Duke Power Company
Oconee Nuclear Station
Attachment 1

<u>Remove Pages</u>	<u>Insert Pages</u>
2.1-2	2.1-2
2.1-3	2.1-3
2.1-5	2.1-5
2.3-1 through 2.3-4	2.3-1 through 2.3-4
2.3-6	2.3-6
2.3-7	2.3-7
3.1-1	3.1-1
3.1-2	3.1-2
3.5-9	3.5-9
6.9-1	6.9-1

No Significant Hazards Consideration Evaluation

Oconee Unit 3, Cycle 12 Reload Report

Figure 2.1-2
OCONEE NUCLEAR STATION

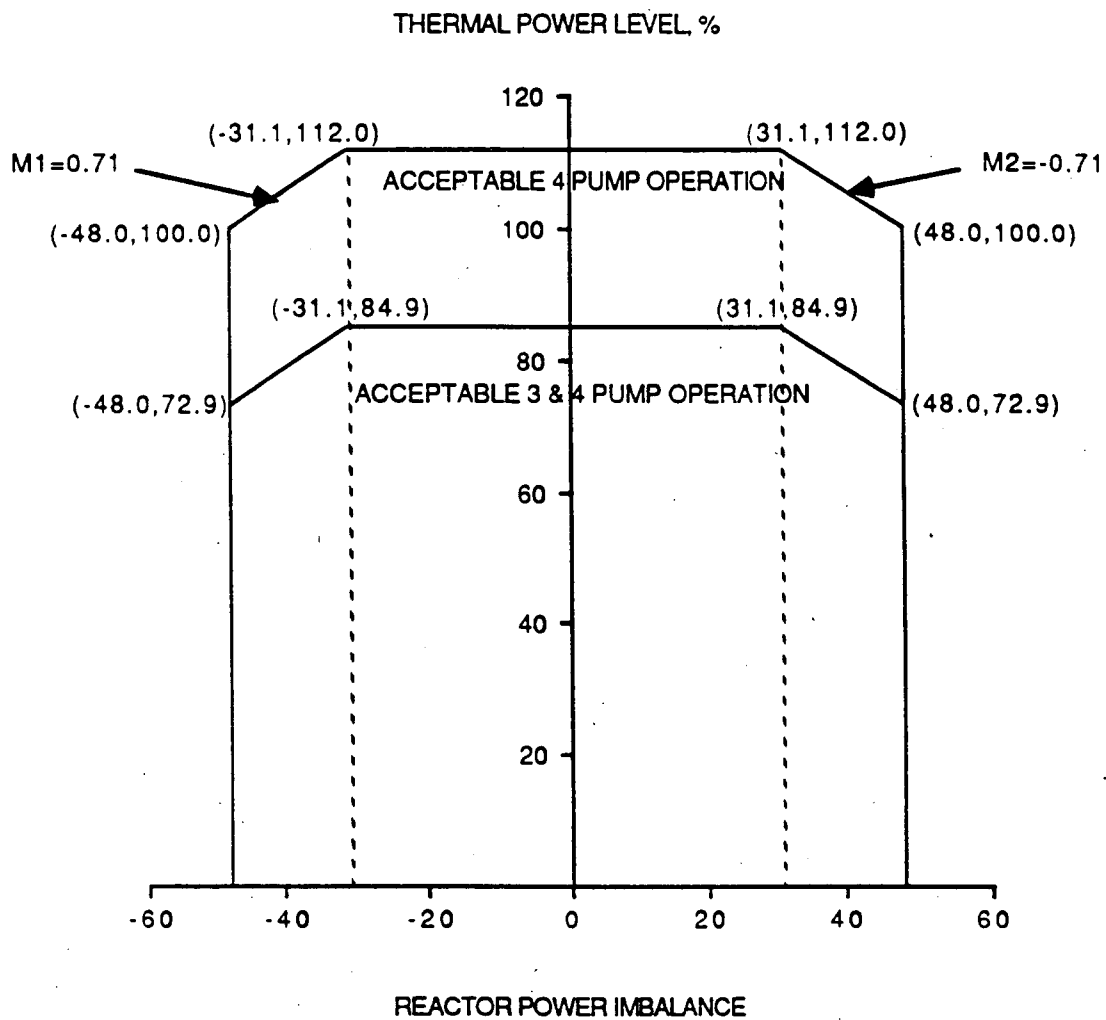
Figure 2.1-2(5), define the values of reactor power as a function of axial imbalance that correspond to the more restrictive of two thermal limits - MDNBR equal to the DNBR limit or the linear heat rate equal to the centerline fuel melt limit.

The core protection safety limits are based on an RCS flow less than or equal to 385,440 gpm (4 pump operation). Three pump operation is analyzed assuming 74.7 percent of four pump flow. The maximum thermal power for three pump operation is 84.9 percent (Figure 2.1-2) due to a power level trip produced by the flux/flow ratio (74.7 percent flow x 1.07 = 79.9 percent power = 84.9 percent power adding the maximum calibration and instrument error).

Figure 2.3-2

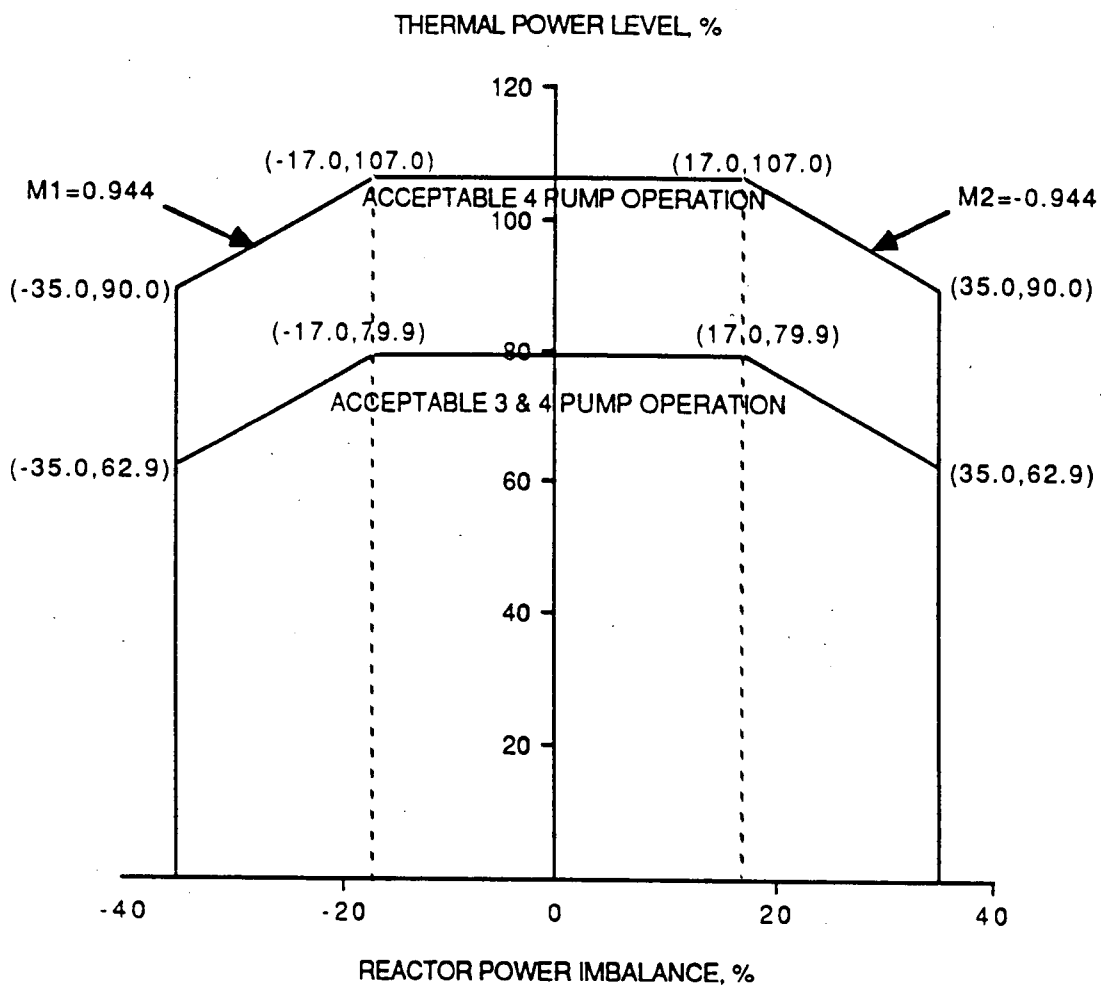
The reactor power imbalance (power in the top half of the core minus the power in the bottom half) reduces the power level trip produced by the flux/flow ratio as shown in Figure 2.3-2. The flux/flow ratio reduces the power level trip and associated power-imbalance boundaries by 1.07% for a 1% flow reduction. The power-imbalance boundaries shown in Figure 2.3-2 are established to prevent fuel thermal limits, DNBR and centerline fuel melt limits, from being exceeded.
